UNITED STATES PATENT AND TRADEMARK OFFICE

10/777,157

Office Action Summary	Application No. 10/777,157	Applicant(s) MAYAMA ET AL.	
	Examiner Terry L. Englund	Art Unit 2816

DETAILED ACTION

FIG. 2

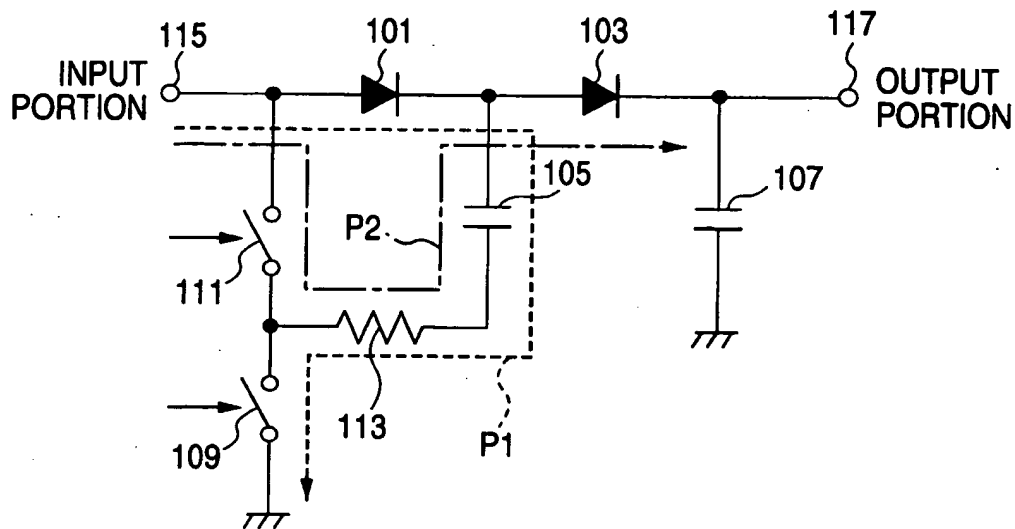
The drawing changes overcame the objections to Figs. 2, 4, and 5 as described in the previous Office Action. Therefore, those changes have been approved, and the drawing objections have been withdrawn.

The attached replacement drawing sheets makes changes to Figs. 2, 4 and 5 and replace the original sheets with Figs. 2, 4 and 5.
